From: Ameen Walli-Attai [REDACTED]
Sent: Thursday, January 20, 2022 7:01 PM
To: Angela Janzen
Cc: Jill Hogan; Nancy Reid; rick@dilorenzo.com
Subject: Re: FW: Sundial (4th Line) Subdivision Proposal (24T-21006/M) - Inquiry Relating to Cycling Facilities

I have a question about [Staff Report DS-003-22](#) in the topic of cycling facilities.

Figure 5.9 – Bicycle Lane at a Single Lane Roundabout, No Bicycle Bypass

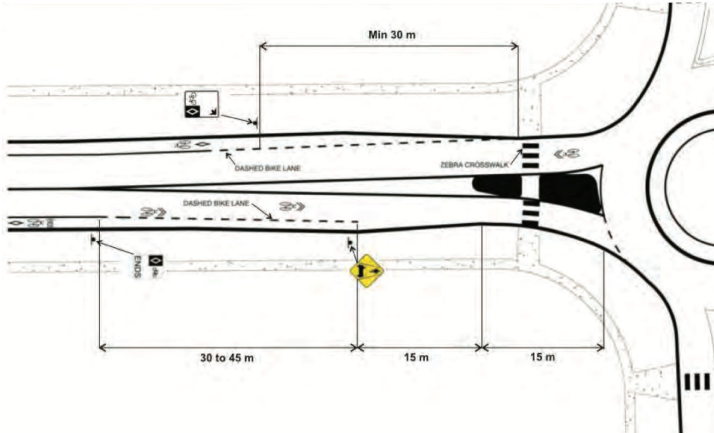
Notes: Very similar to Figure 2

I don't know why Milton staff have not been ensuring that appropriate cycling facilities were implemented in the past. As you see in figure 2 and 3, cyclists are expected to MERGE with car traffic at the roundabout. Does this make any sense to you? I mean, how do you expect kids to cycle to school when they are expected to merge with car traffic at roundabouts, and are provided with insufficient space to bike?

Figure 6.81 – Single-Lane Roundabout, PXO Crossing Treatment

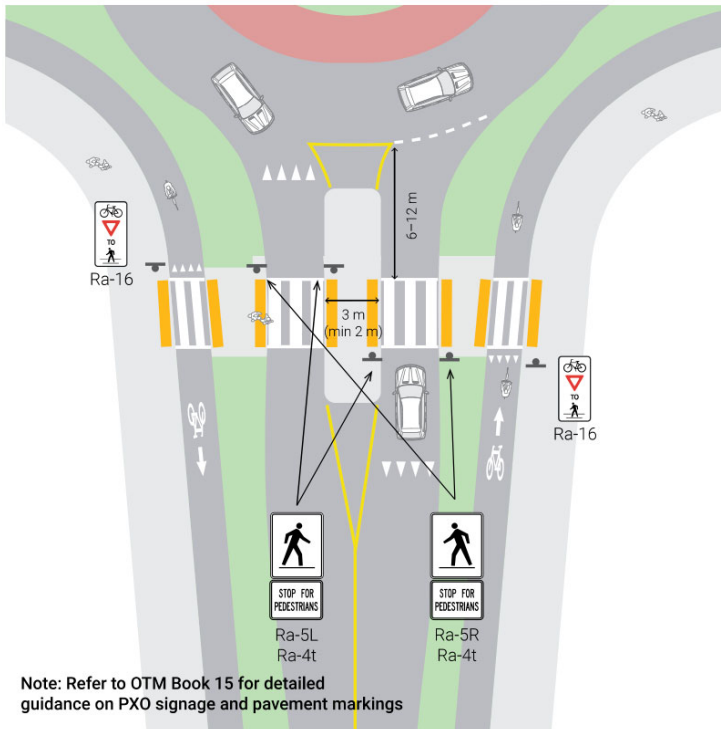
Notes: Accommodates the need of cyclists as they are vulnerable road users and recognises that the "design cyclist" (average person) should not be expected to merge with car traffic

I think the plan lacks clear objectives; it is very vague. Clearly, the Boyne Survey Secondary Plan was not followed in past developments because the on-road bike lanes in figure 2 don't seem to comply with the Town's Trail and Cycling Master plan - as I am pretty sure the bike lanes are only 1.5 m in figure 2 (please correct me if I am wrong). Further, bicycle bypasses are recommended at roundabouts, and clearly from comparing figures 2 and 4, this was not followed either.

Below is an excerpt of the Boyne Active Transportation and Natural Heritage System Plan (Schedule C.10.B) which shows in yellow, where on-street bike lanes and trails are to be provided within the Boyne area and specifically within this subdivision.

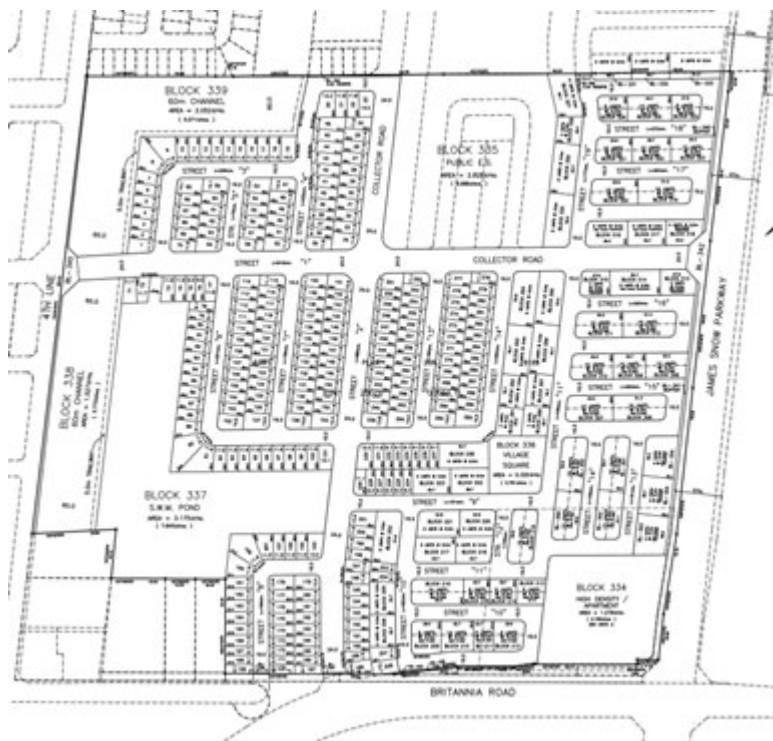
In terms of the first image you shared, it doesn't look like every road has cycling facilities even though it should. Also, all multi-use paths should have cross-rides at intersections because guess what, it's against the Ontario Traffic Act to bike on crosswalks. Further, all roads/ streets without bike lanes should have maximum speed limits of 30km/h as outlined in Table 5.3 from OTM Book 18 which I shared in my first email.

This includes on-street bike paths on the north/south and east/west collectors that cross through the subdivision, multi-use trails that will run along the watercourse and stormwater pond, and also connections along James Snow Parkway and Britannia Road, which are both regional roads. These facilities will connect to other development areas and be part of the overall trail network.

Figure 4.34 – Cross-Section of One-Way Physically Separated Bicycle Lanes

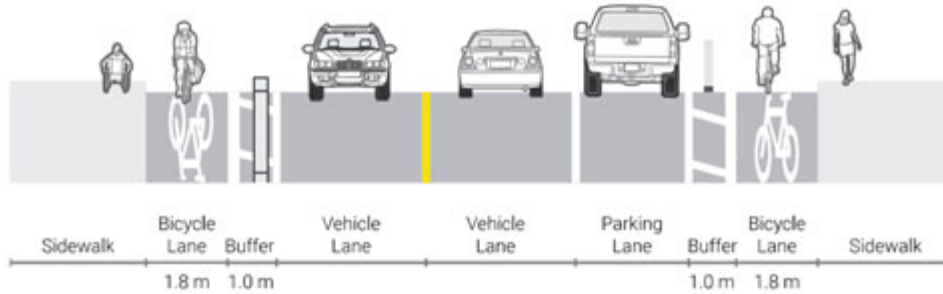
Further, for cycling facilities to meet minimum guidelines, they should also be of the specified minimum widths and separations from vehicular traffic. For example, a bicycle lane beside car parking should have a desired width of 1.8m plus a 1.0m buffer to prevent "dooring" as per Table 4.3 from *OTM Book 18: Cycling Facilities*:

This configuration may take up lots of space so trying to separate cyclists from drivers is better. For example, not having car parking beside cycle lanes, adding cycle tracks instead of cycle lanes, adding multi-use paths with cross-rides, adding advisory bicycle lanes, etc.
